AMENDMENTS TO THE DRAWINGS:

REMARKS

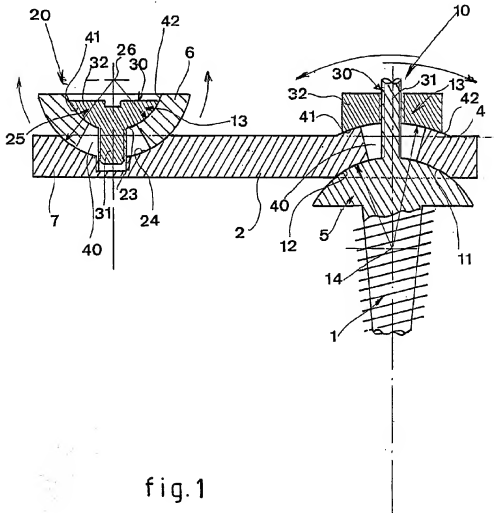
A replacement drawing is submitted for Figure 1 adding the symbol "" to elements 30, 31, 32, 40, 41 and 42 on the left-hand side of the figure to distinguish these elements from those on the right-hand side of the figure.

A replacement drawing is submitted for Figure 1 adding the symbol "" to elements 30, 31, 32, 40, 41 and 42 on the left-hand side of the figure to distinguish these elements from those on the right-hand side of the figure. Although the terminology used in the specification is the same, nevertheless, the above-noted elements are directed to a different embodiment as disclosed on page 4, line 21 to page 5, line 4. The above change is the only change and is believed not to introduce new matter.

By way of example, Figure 1 of the present application, reproduced below shows screwing head 32 is screwed onto said threaded shank 31. Faces of the screwing head 32 (face 41) and of a hemispherical portion (unnumbered having face 42) that comes into contact with the screwing head are of complementary hemispherical shapes.

By way of example, Figure 1 of the present application, reproduced above, shows face 41 of the screwing head 32 on the right-hand side of the figure and face 42 of the hemispherical portion that comes into contact with the screwing head 32 are respectively concave and convex.
